October 6, 2023

Office of Air Resources  
RI Department of Environmental Management  
[elizabeth.stone@dem.ri.gov](mailto:elizabeth.stone@dem.ri.gov)

### **Proposed GHG Accounting Updates**

**Figure 1: Rhode Island's Gas Leak Estimates vs. Total Unaccounted for Gas**

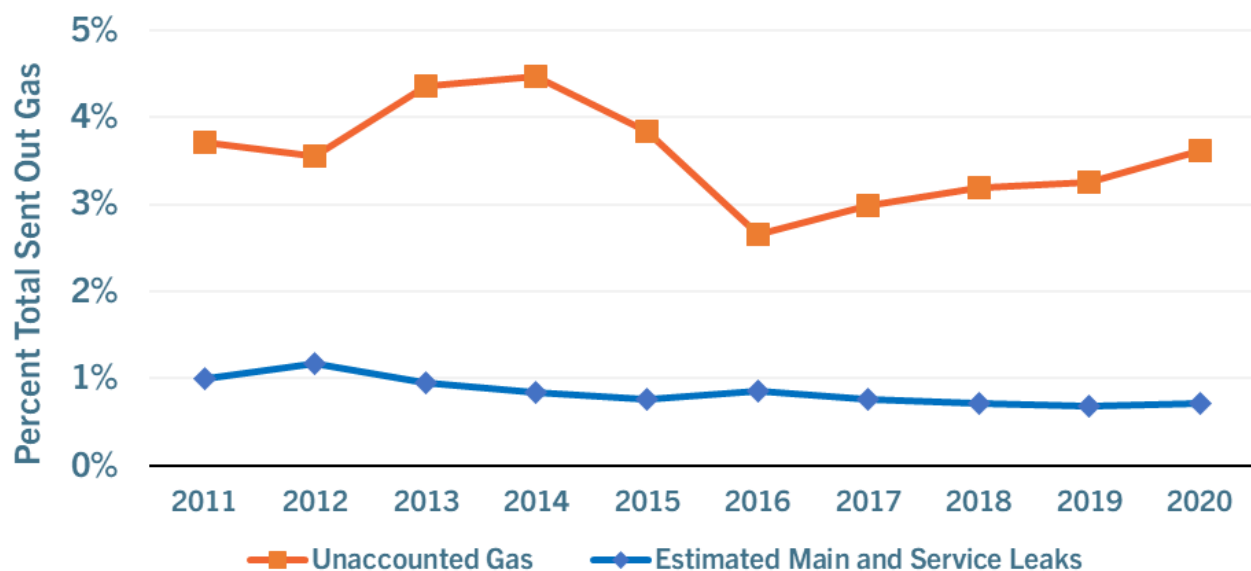
There is a high degree of uncertainty surrounding the level of methane leaks from the gas distribution system. There is a large, unexplained, disconnect between the percent of unaccounted for gas in Rhode Island (3.61% in 2020) and the level of estimated main and service leaks in the gas system used to inform the state’s GHG Inventory (0.71%).<sup>3</sup> The approach of only quantifying main and service leaks also ignores behind-the-meter gas leaks which may be significant based on literature review. Additionally, a long-term study by Harvard scientists found six times more methane leaking into the air in the Boston metro region from the gas system than reported according to the EPA methodology used in the Massachusetts GHG Inventory<sup>4</sup> (this methodology is also used in the Rhode Island GHG Inventory). The study estimated that the metro region within a 28-mile radius of the Boston city center was estimated to have a 4.7% gas leak rate from “well pad to urban consumer” and the study observed no changes to the level of methane emissions in the Boston area over 8 years despite significant efforts to slow the rate of leaks from the gas system.

From 2016-2020, Rhode Island decreased the amount of unprotected steel gas mains by 24.0% and decreased the miles of cast iron steel gas mains 12.6%, yet the level of unaccounted for gas in Rhode Island over that same time period has risen every year – from 2.65% in 2016 to 3.61% in 2020.<sup>5</sup> Similar to the issue of lifecycle accounting for biofuels, there is no “easy fix” currently available, but that should not reduce the level of urgency in addressing this GHG accounting uncertainty. Rhode Island should be actively monitoring the evolving field of methane leak measurement and, when applicable, looking to incorporate the new, emerging methodologies for quantification of methane leakage into the state’s GHG inventory. Active collaboration with other states and federal agencies will be critical.
